UNITED STATES
DEPARTMENT OF THE INTERIOR
BUREAU OF LAND MANAGEMENT

SUNDRY NOTICES AND REPORTS ON WELLS
Do not use this form for proposals to drill or to re-enter an abandoned well. Use form 3160-3 (APD) for such proposals.

8. Well Name and No.
BIGGERS FEDERAL 215H

Matador Resources respectfully requests to amend the casing, cementing and mud program on the Biggers Federal #215H (30-025-44484).

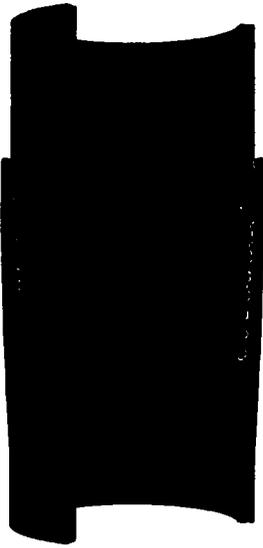
- Matador requests a variance to run 7-5/8" BTC casing inside 9-5/8" BTC casing which will be less than the 0.422" stand off regulation. Matador has met with Christopher Walls and Mustafa Haque as well as other BLM representatives and determined that this would be acceptable as long as the 7-5/8" flush casing was run throughout the entire 300' cement tie back section between 9-5/8" and 7-5/8" casing.
